Review of the Project Group:
Group Code: AP1000 51
Full title: AP 1000

SH2702 - Nuclear Reactor Technology
Master programme in Nuclear Energy Engineering

AP 1000

Team 51
Nicolas Andrade
Ian Gilley

Figure 13: Axial pressure drop in average and hot channel.

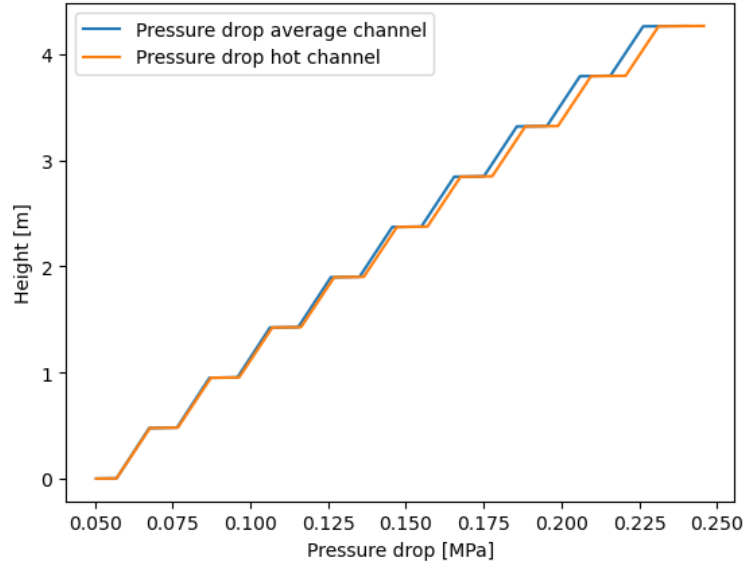
5. <i>Calculate</i> CHF margins in a hot channel (Task 5, ILO4a)	3	A brief explanation of CHF and DNBR. Shouldn’t the height be the abscissa/x-axis in Fig. 13?
